XTO Permian Operating LLC Respectfully requests approval to perform the bradenhead squeeze in the intermediate 2 casing after fracing operations as per Figure D in the R-111-Q document. I have attached updated design in the email. There are no changes to proposed casing points & grades and cement program top in the approved APDs

R-111-Q: Potential Potash Pivot Well Design

Operator: XTO PERMIAN OPERATING LLC. 6401 HOLIDAY HILL ROAD MIDLAND, TX 79707	OGRID: 373075
	Action Number: 419282
	Action Type: [C-103] NOI Change of Plans (C-103A)

[Figure D] 4 String – Uncemented annulus between 1st and 2nd intermediate casing strings

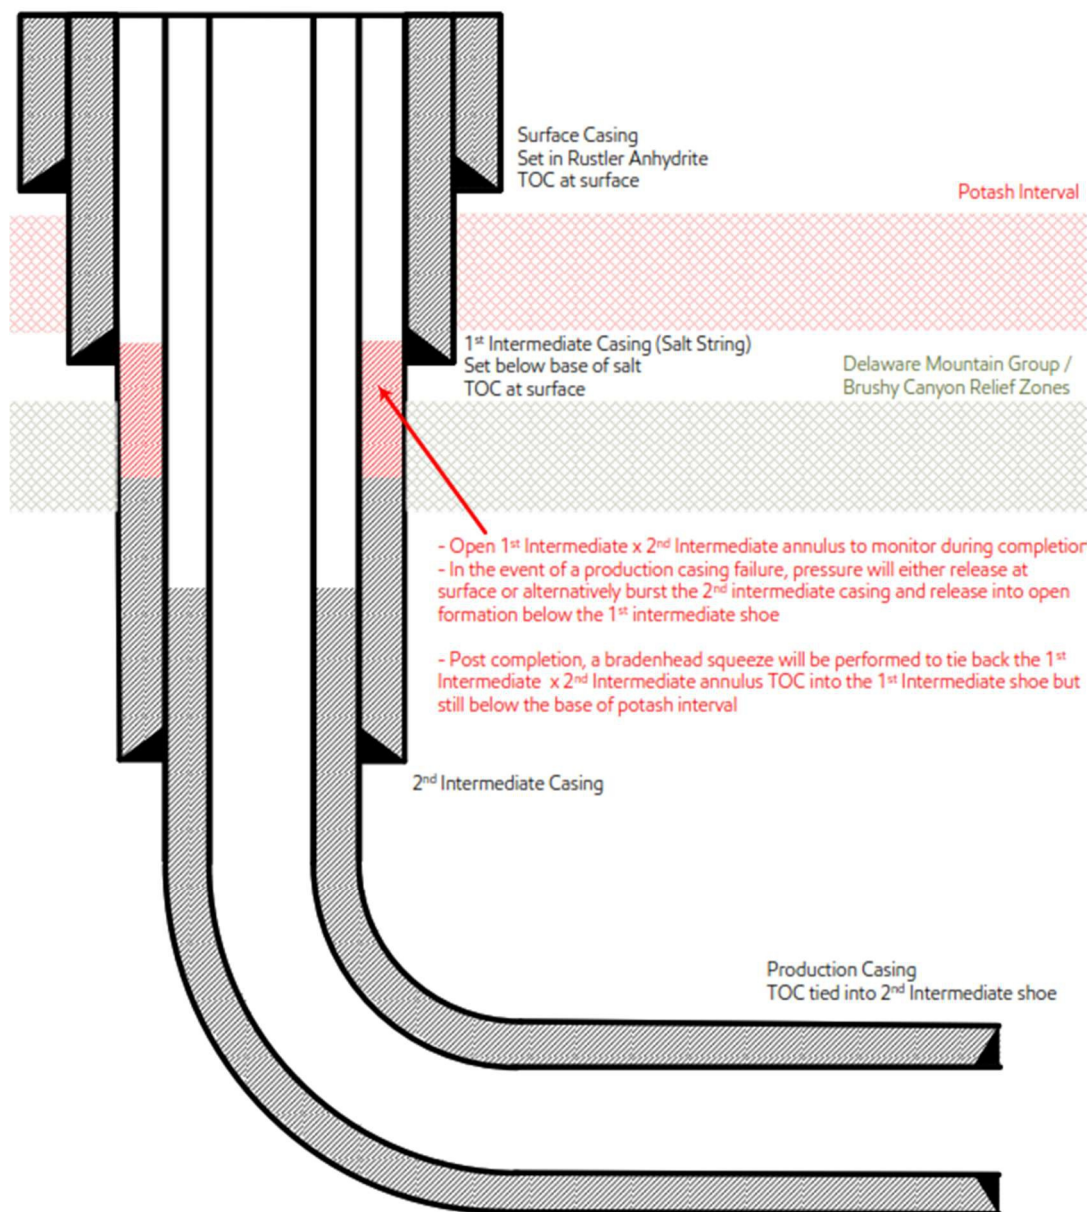
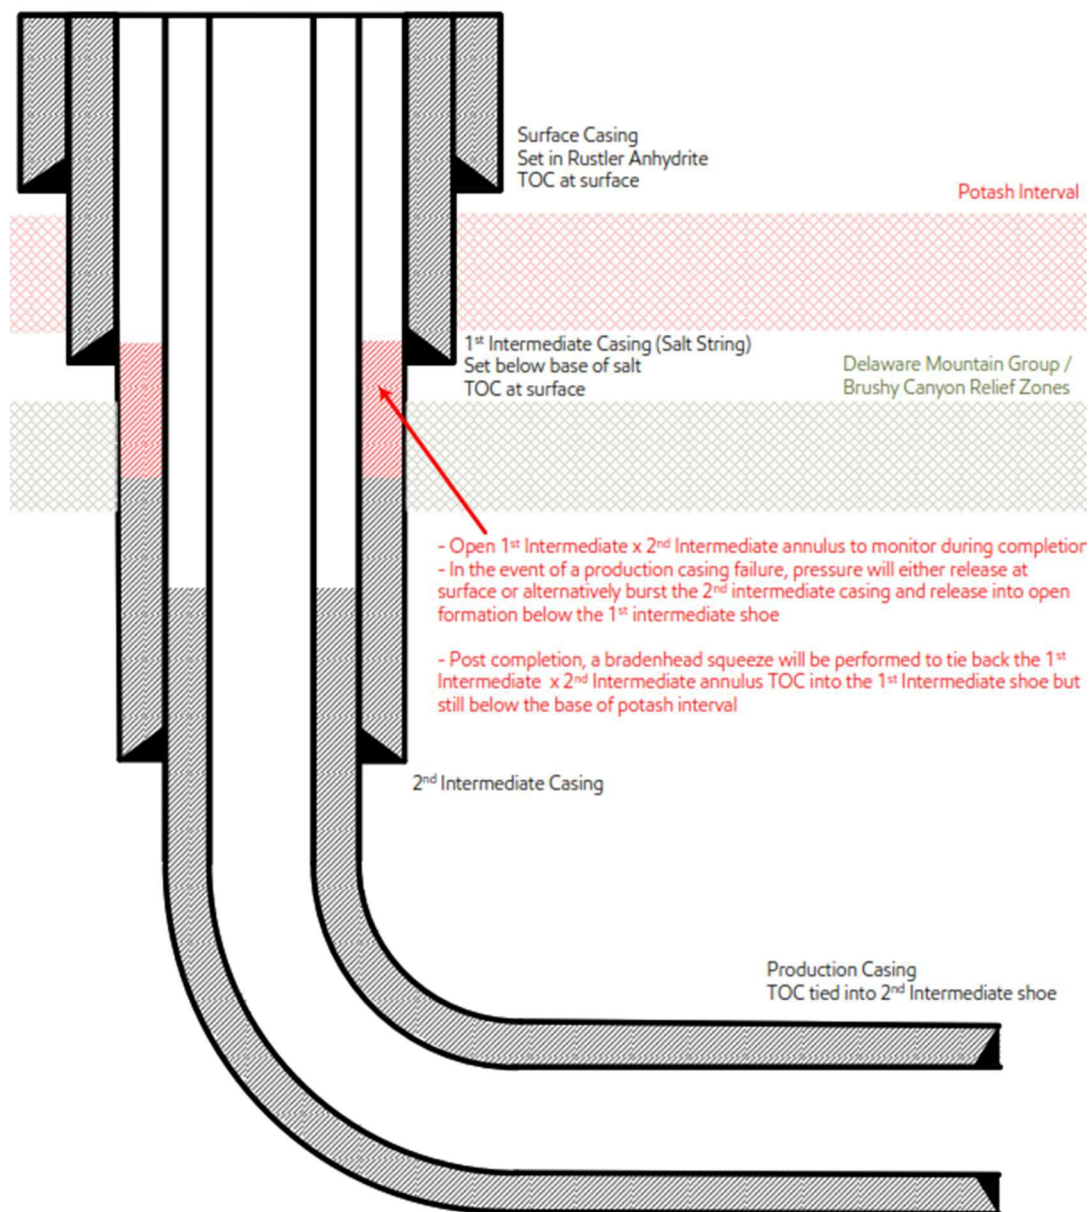
- 1) Alignment with KPLA requirements per schematic above, leaving open annulus open for pressure monitoring during frac and utilizing new casing that meets API standards.
- 2) Contingency plans in place to divert fluids away from salt interval in event of production casing failure.
- 3) Bradenhead squeeze to be completed within 180 days to tieback TOC to salt string at least 500ft but with top below Marker Bed 126.
- 4) Production cement to be tied back no less than 500ft inside previous casing shoe.

Created By	Condition	Condition Date
ward.rikala	Any previous COA's not addressed within the updated COA's still apply.	1/10/2025
ward.rikala	This well is within the R-111-Q potash area. The 1st intermediate casing string shall be cemented back to surface. Immediately following the cementing of the 2nd intermediate casing string, a CBL is required to document where the TOC is located. Immediately following the cementing of the production casing string, a CBL is required to document where the TOC is located. The bradenhead cement squeeze post frac shall provide a minimum of 500' of tie back into the 1st intermediate casing string.	1/10/2025

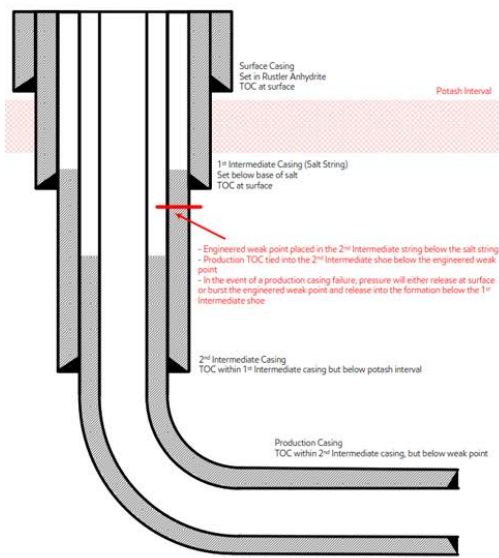
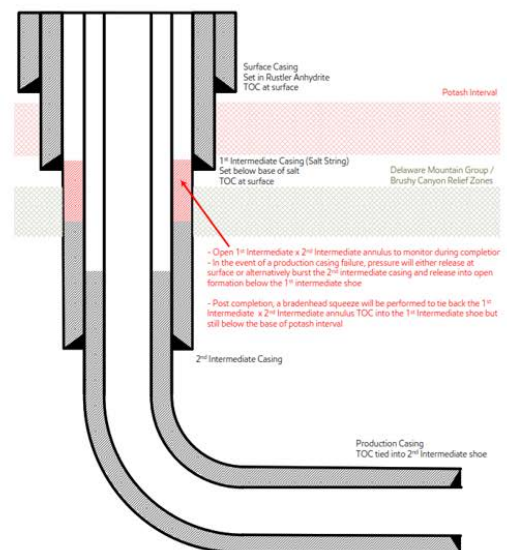
CURRENT 4-string design

POTENTIAL pivot 4-string design
